**56 Hawtrey Road  
London NW3 3SS**

**Basement Impact Assessment  
Audit**

London Borough of Camden

Project Number: 12066-15  
Rev: F1

**SECTION 4 - 4**

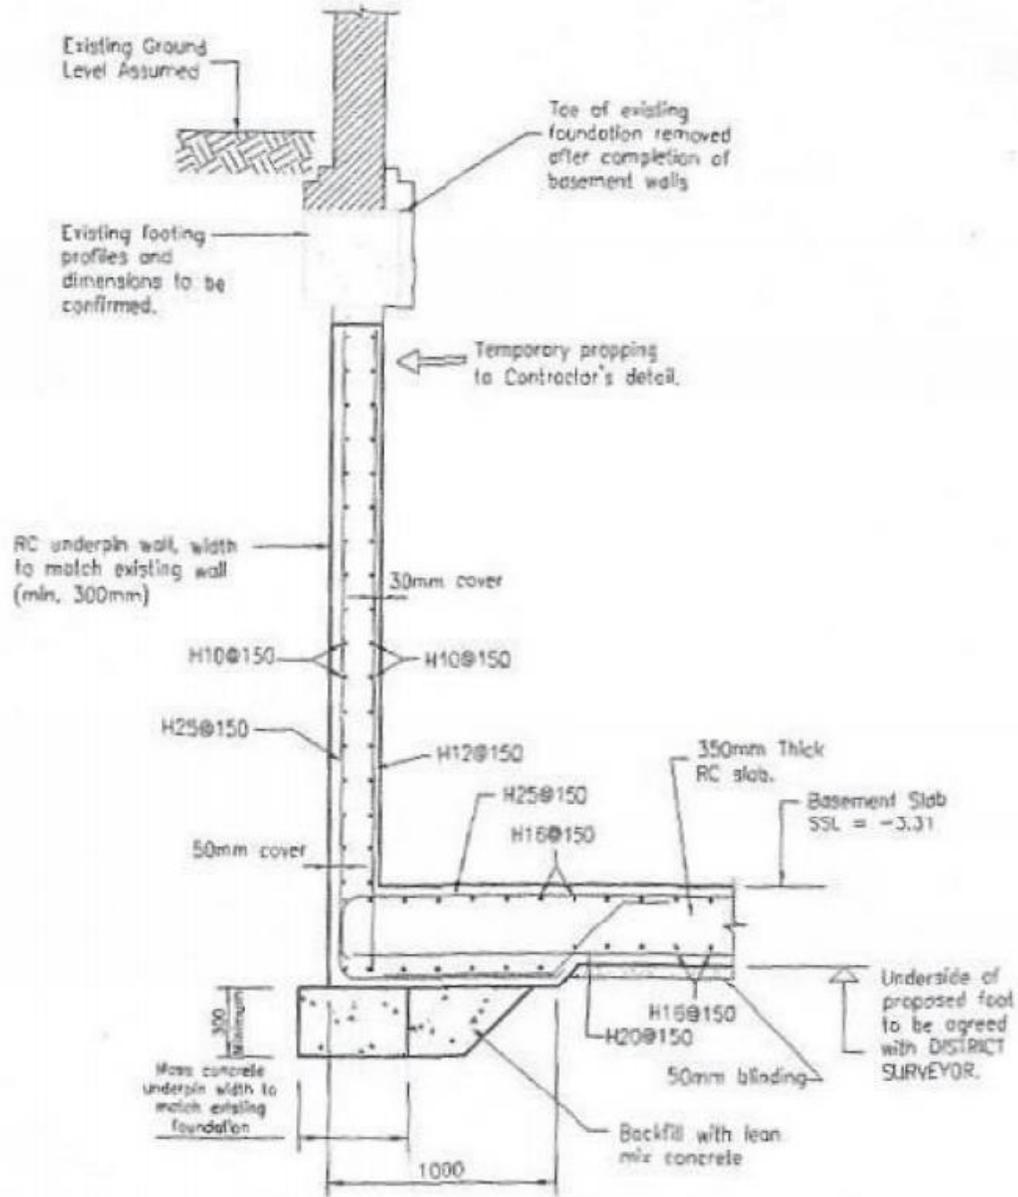
1. Whilst there are no additional vertical loads, the foundations are deeper and will be stressing soils that were previously below the zone of influence of the foundations. Some settlement might therefore be expected.
2. As above.
3. Accepted.
4. There will be some settlement as noted above, as well as horizontal movements (Substructural say that calculations of horizontal movement have been provided - can these be sent to us?)

- 2 The transfer of the vertical loads will occur by the underpinning of the existing footing to a depth appropriate to reflect the proposed basement excavation. This load will be re-applied to the soils by a mass concrete foundation beneath the basement (see attached sketch)

- 3 The introduction of the reinforced slab at the basement floor level is twofold:
  - a. It is utilised to distribute the lateral loads applied to the basement wall from the retained material

- b. It is utilised to restrict uplift from potential clay heave (nominal) and water pressure
- 4 As there is no proposed increase in loading and lateral loads are addressed by a suitably stiff basement wall, we anticipate that movement to adjacent/Party walls are negligible. Calculations have been provided in respect of lateral movement to the basement walls. As vertical loading remains the same and the ground becomes 'stiffer' with depth vertical settlement is, for all intents and purpose, zero
